A117.1-2009 errata

Updated August 4, 2023

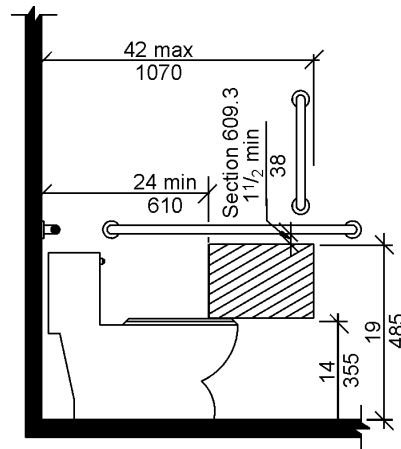
- Page 53: In Figure 604.11.7, the dimension string on the right side should be split into two separate dimension strings as shown in the figure below. The bottom of the hatched area should be located at 14 inches (355 mm) and the top of the hatched area should be located at 19 inches (485 mm).
